OIL - REVISE NO.5 BEARING OIL SCAVENGE TUBE ASSEMBLY ATTACHING PARTS - CATEGORY CODE 6
- MOD.ENG-79-0011

- (1) Aircraft: Airbus A320
- (2) Engine: V2500-A1 Prior to Serial No.V0086

V2500-ENG-79-0011

No.5 oil scavenge tube
Fig.1

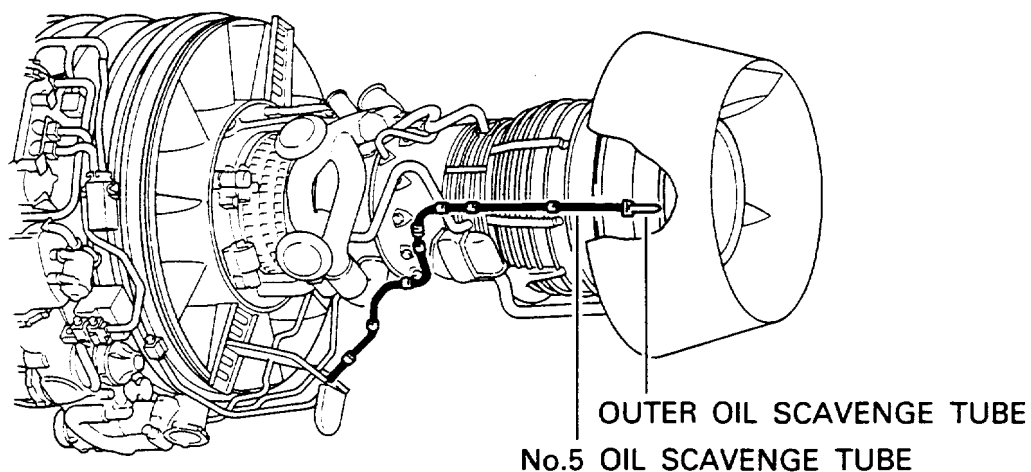
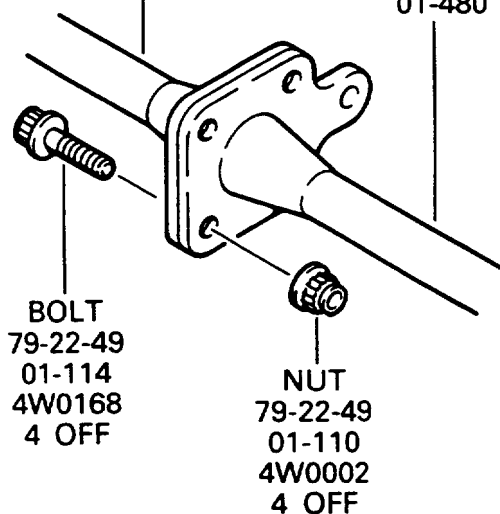
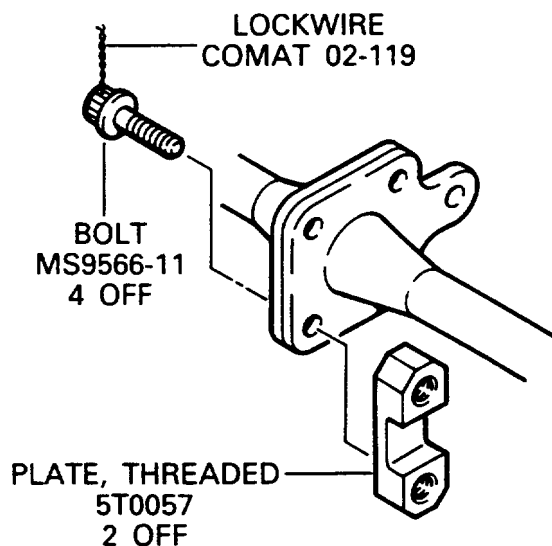
Insufficient clearance may exist when tightening No.5 scavenge tube nuts.

Difficulties have occurred when tightening nuts in the existing configuration.

To ease wrenching by replacing the standard nuts with plates and threads.

- (1) Four nuts are replaced with two threaded plates.

(1) Remove Nuts and Bolts which connect No.5 Oil Scavenge Tube (79-22-49, 01-100) and Outer Oil Scavenge Tube (72-50-53, 01-480), Figure 1.

(a) Remove 4W0002 Nuts (4 off).

(b) Remove 4W0168 Bolts (4 off).

(1) Install Threaded Plates and Bolts, Figure 1

(a) Install 5T0057 Threaded Plates (2 off) and MS9566-11 Bolts (4 off).
Torque Bolts to 75 to 85 lbfin (8,47 to 9,60 Nm).

(b) Safety with CoMat 02-110 lockwire.
